201221/15840
Duct and Pipe SD

SPALDING DRIVE ELEMENTARY SCHOOL – MBA JOB #12017 HVAC DUCT/PIPING SHOP DRAWING SUBMITTAL ENGINEERING COMMENTS

DRAWING BY: **MEROM**
 CHECKED BY: **0**
 DATE: **10/28/13**
 PROJECT NO.: **10/28/13**
MP-L1-MR

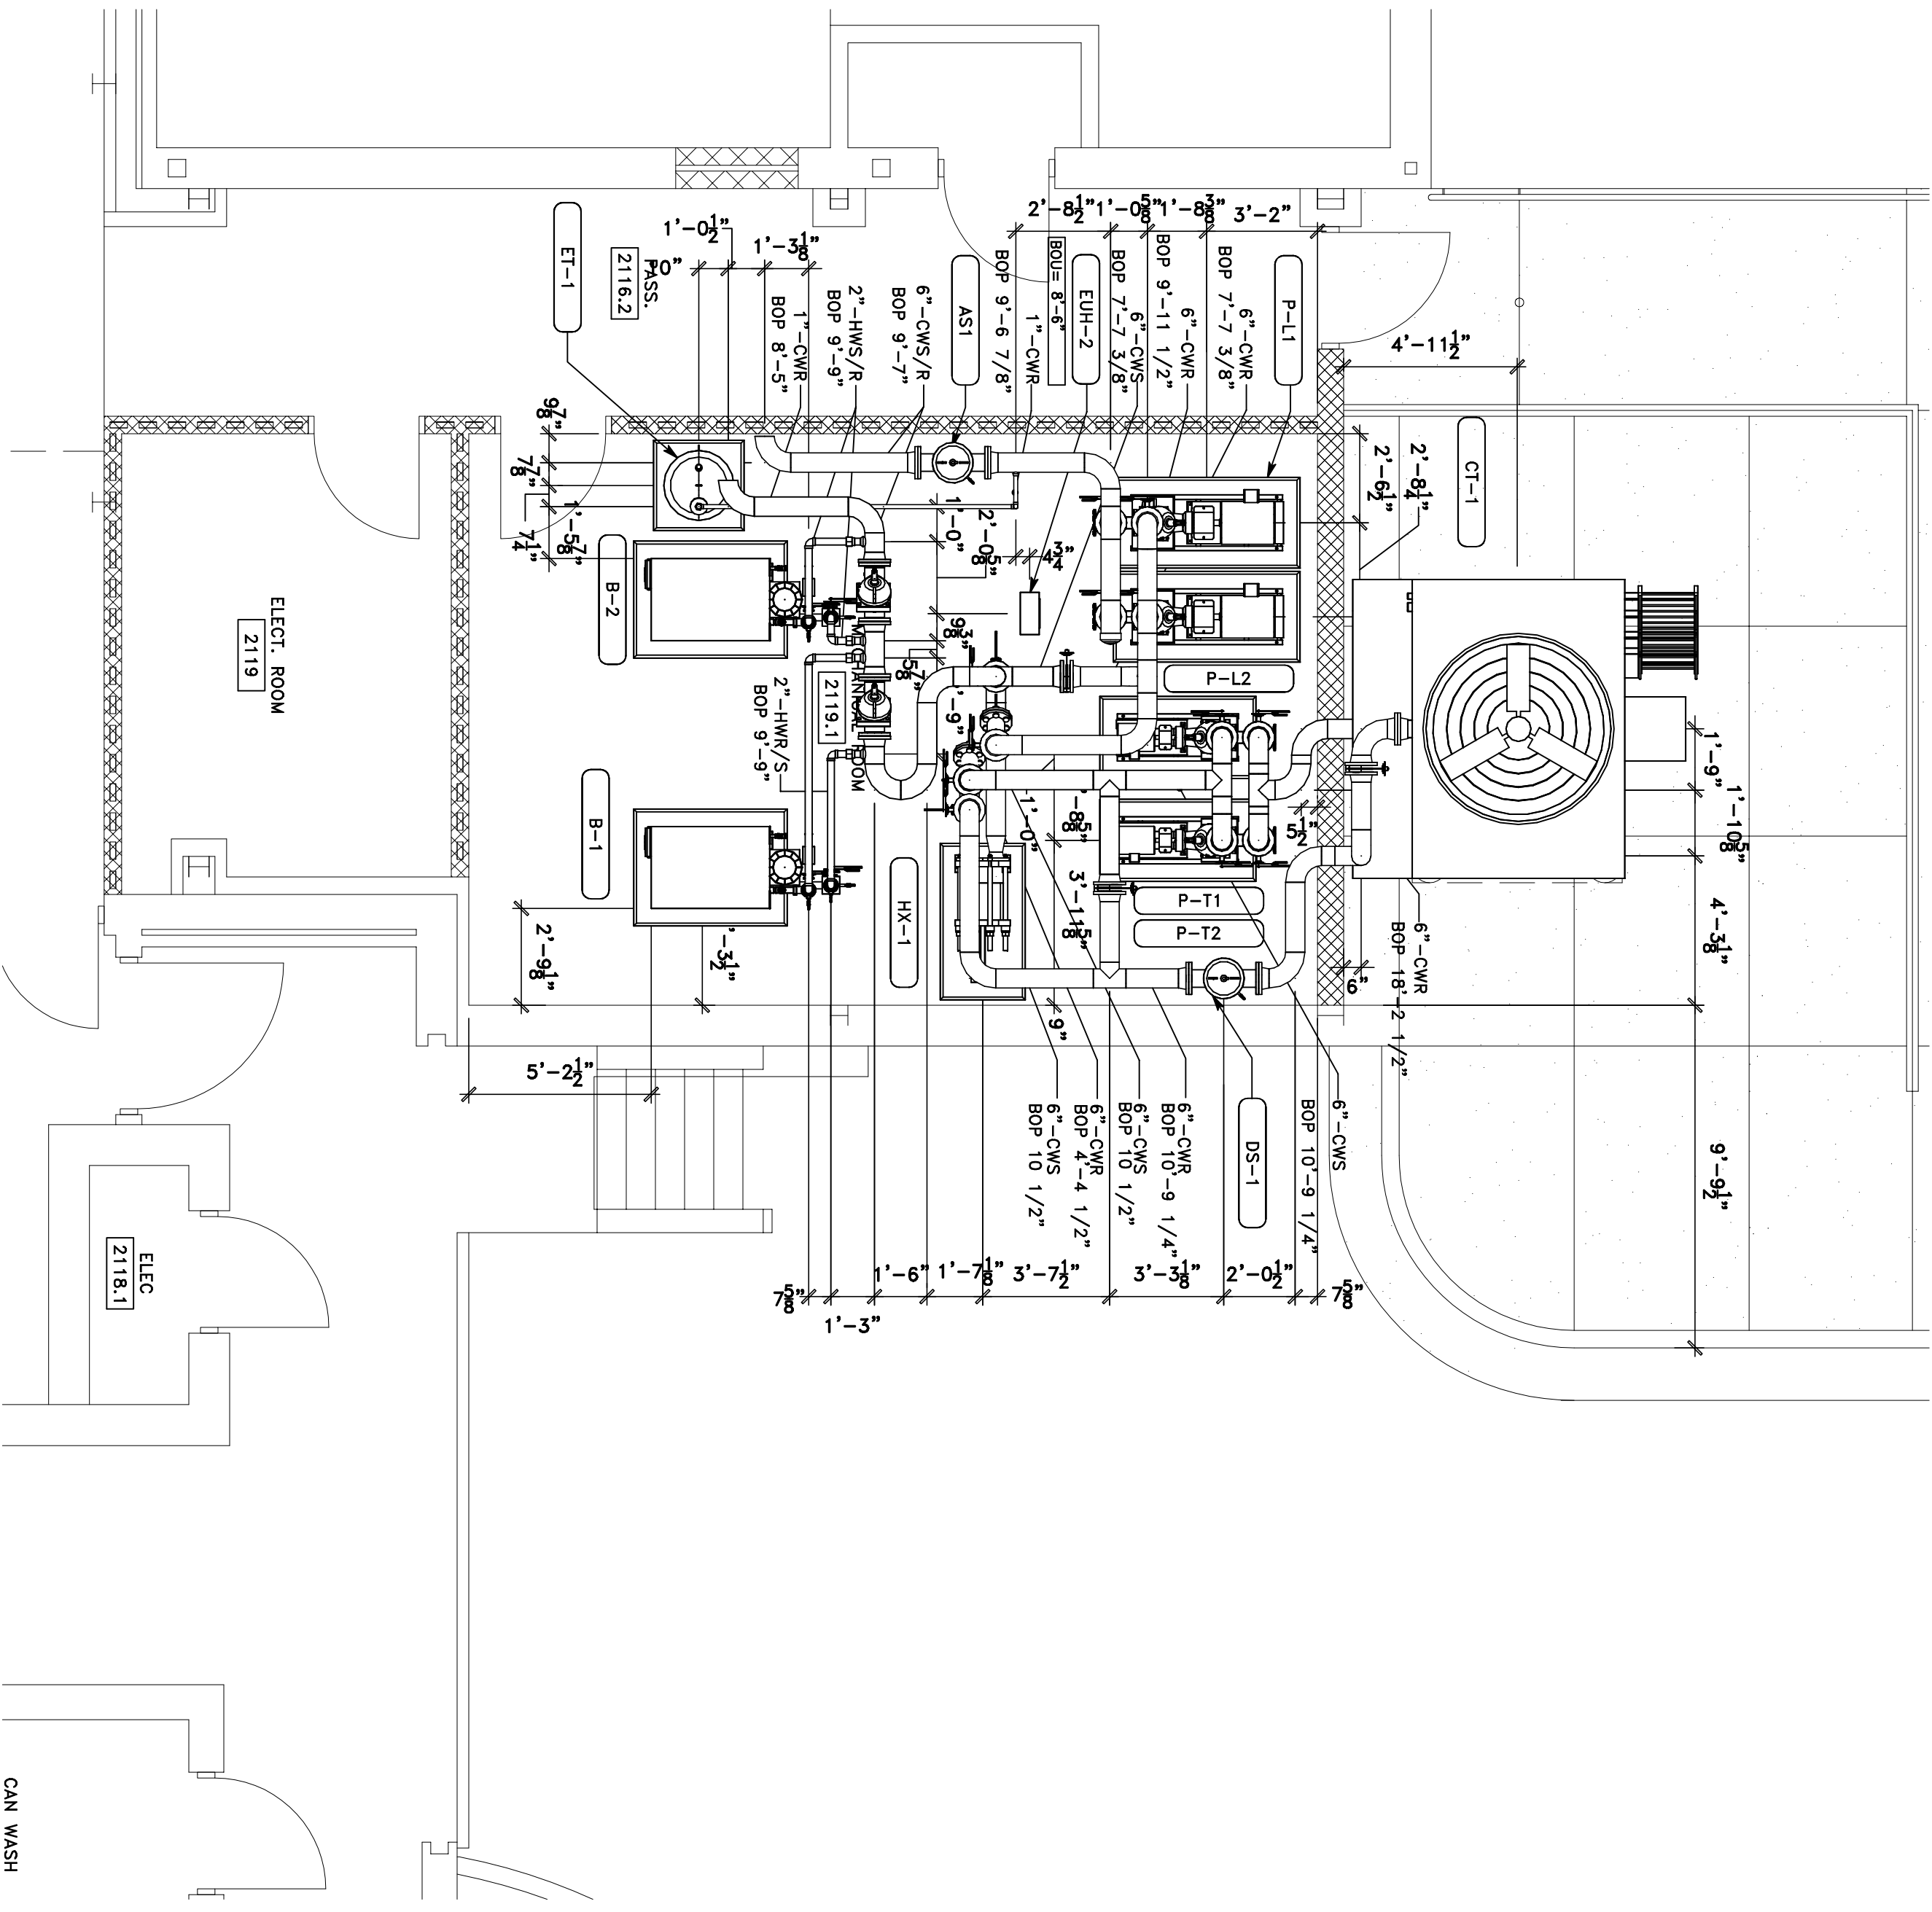
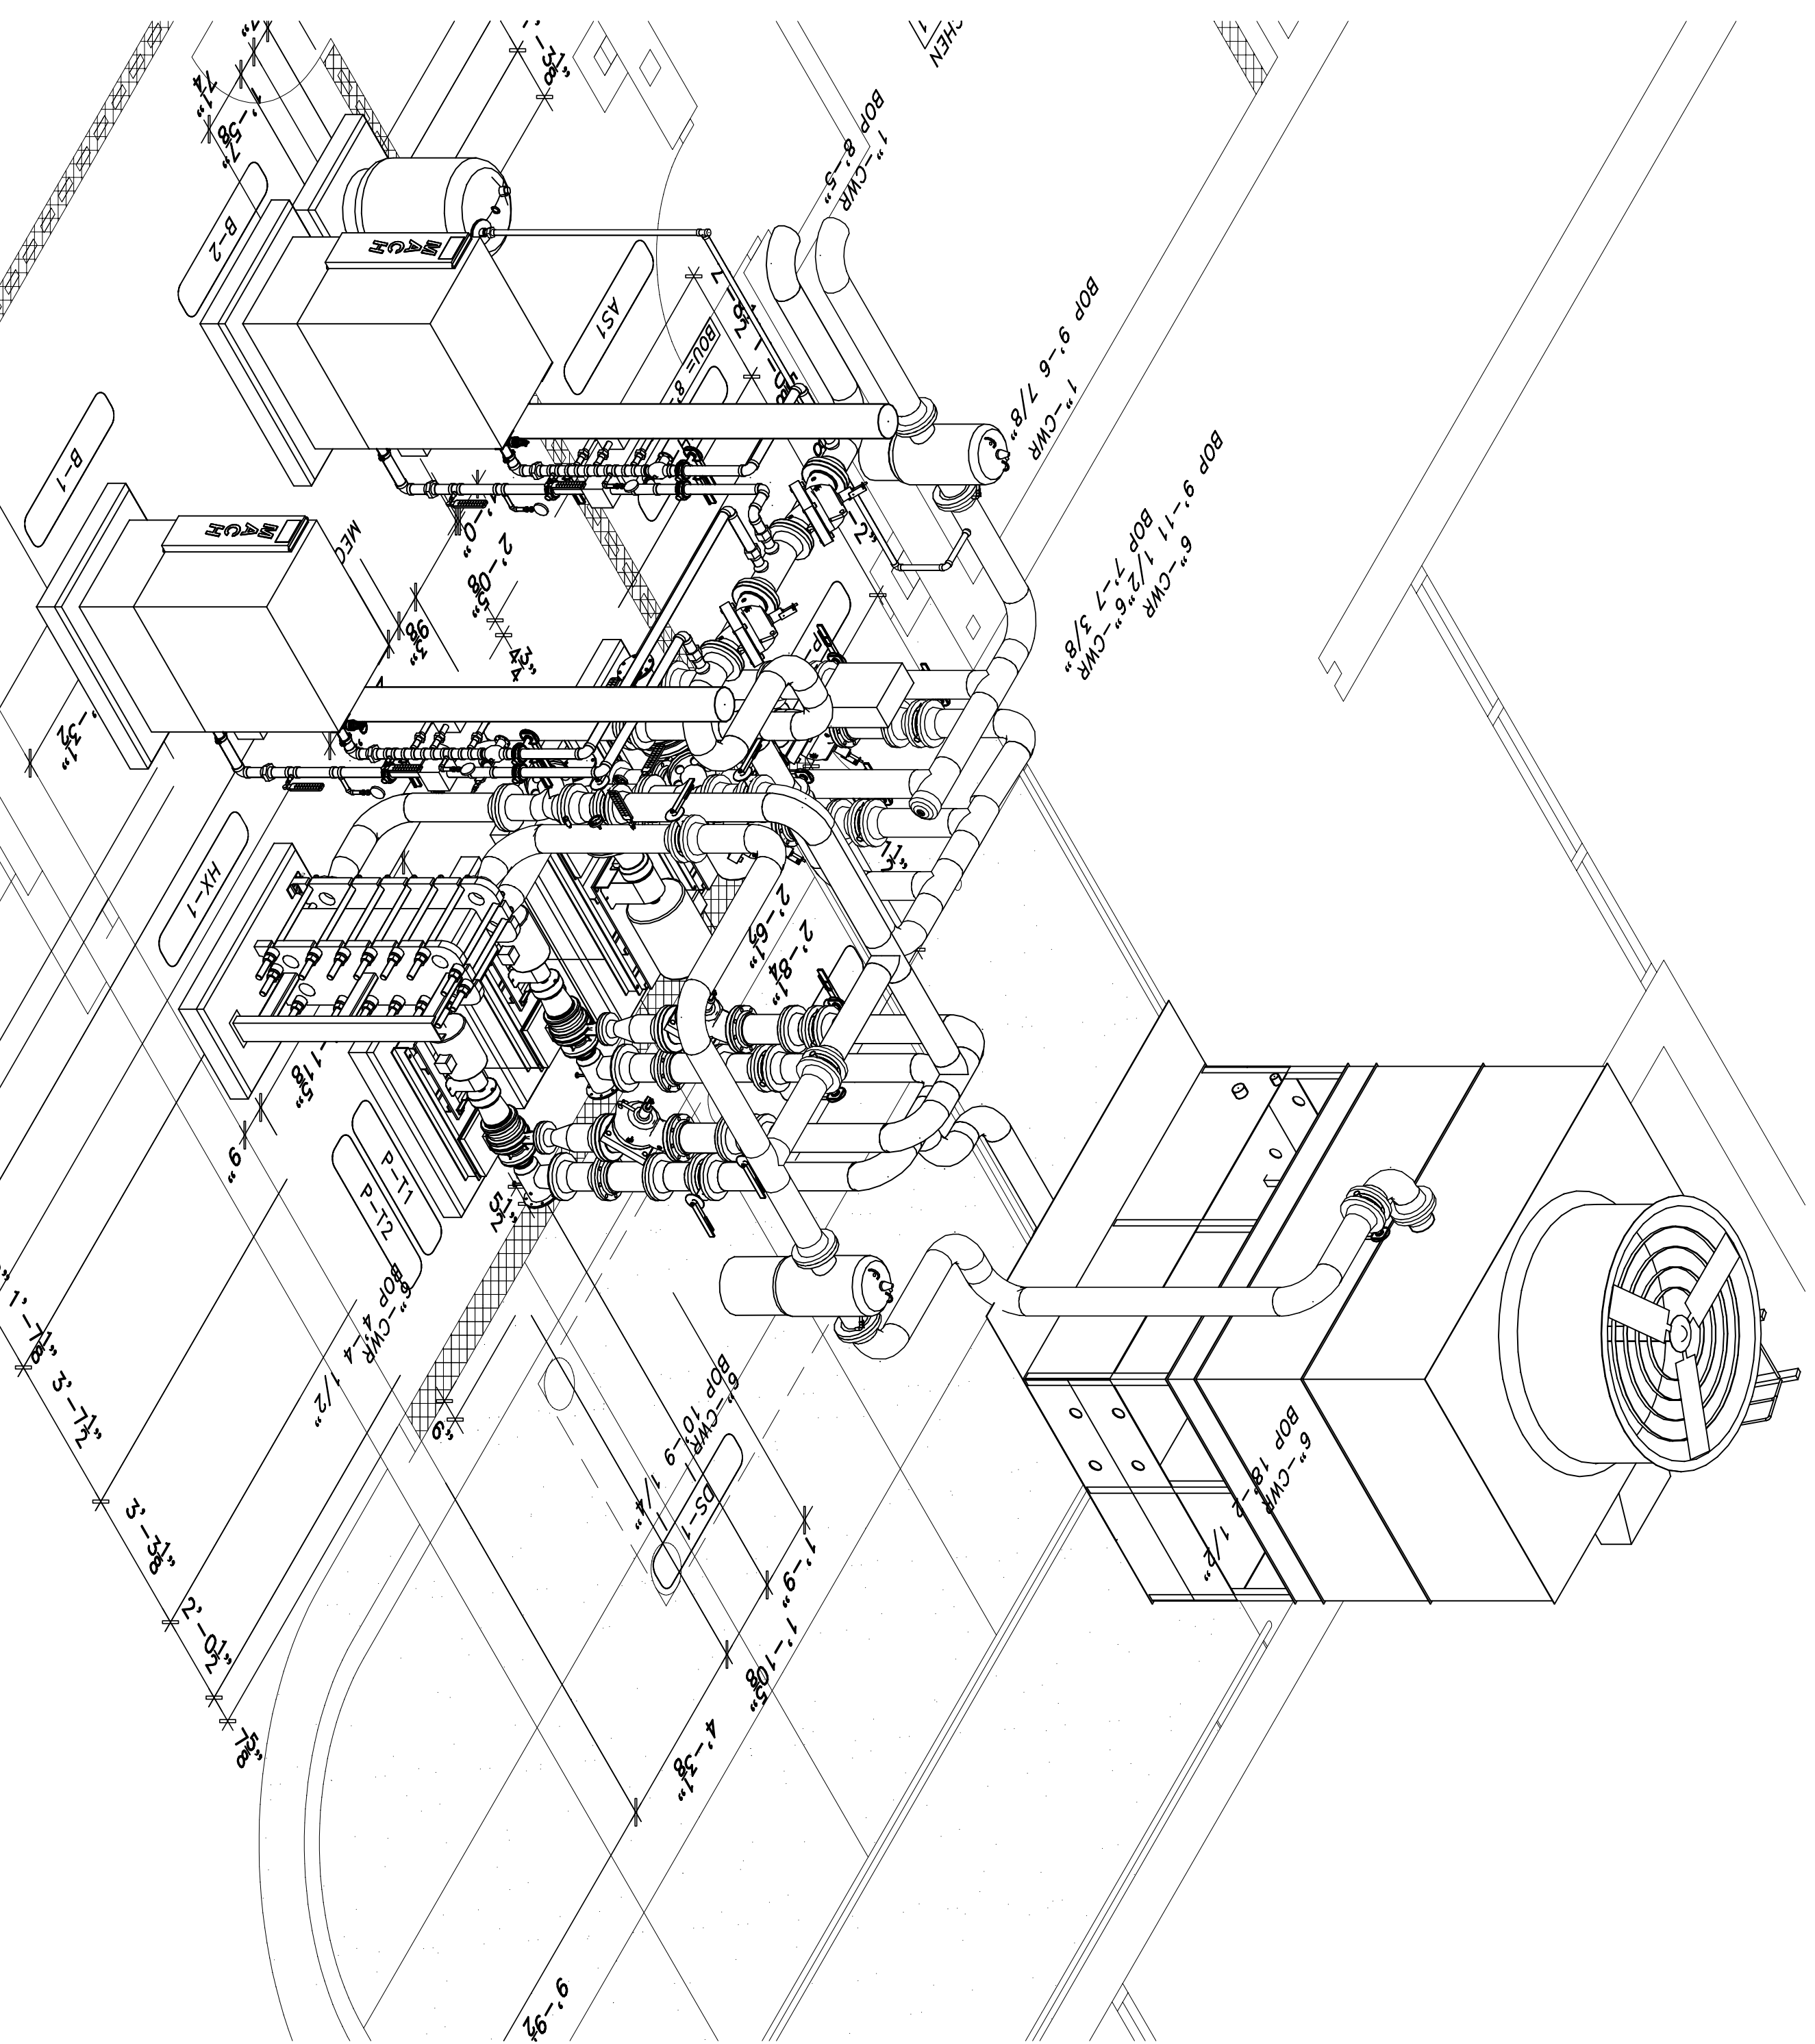
Sheet 17- Mechanical Room Piping Plan – Cooling tower is shown too close to exterior wall – **Correct As Noted**
